Campaign Bulletin 100002

Date: May 7, 2010
Subject: Floor Loading Information
Models and Serial Numbers Affected:
Z-80: Z80-101 to Z8009-2448
Allowable Hours: 30 minutes

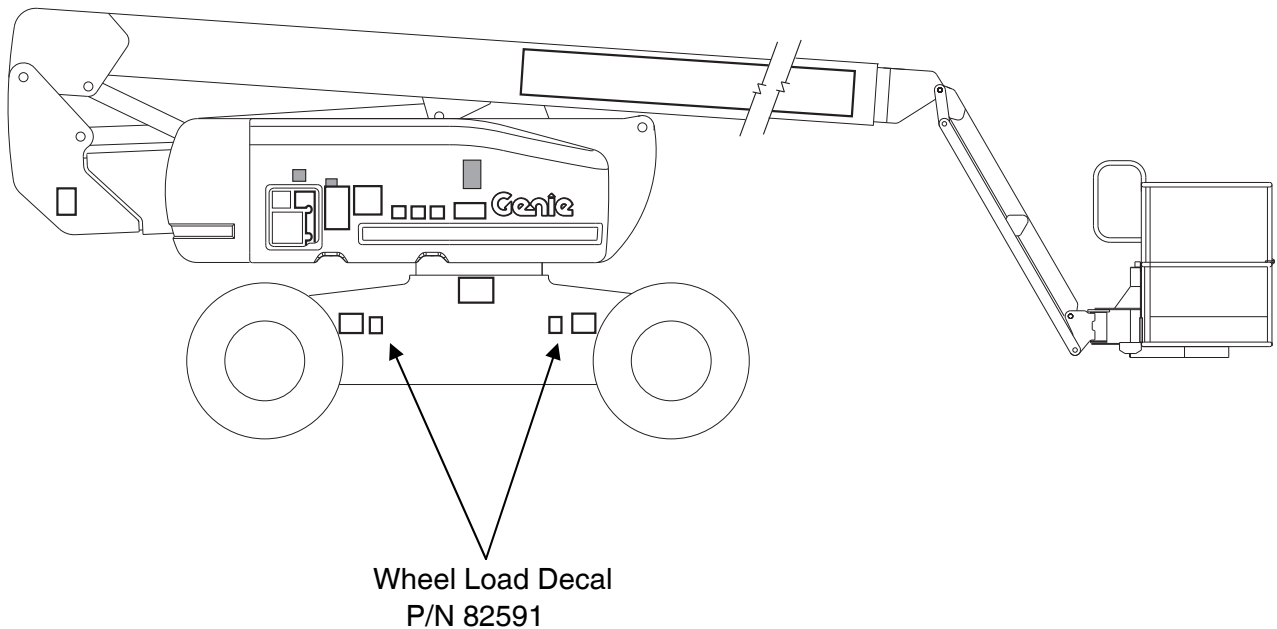
Genie Industries has determined that the above referenced machines were produced with the wrong floor loading information in the operator's manual and on the decals. This information indicates that the maximum wheel load is less than the actual maximum wheel load. **Incorrect floor loading information may result in the user operating the machine on a surface that is not capable of supporting the maximum wheel load.**

5. Upon receipt of the kit, locate and destroy the wheel load decal P/N 82591 on your machine and replace with the decal from the kit.

This bulletin requires replacement of the operating instructions manual and wheel load decals on the above referenced machine.
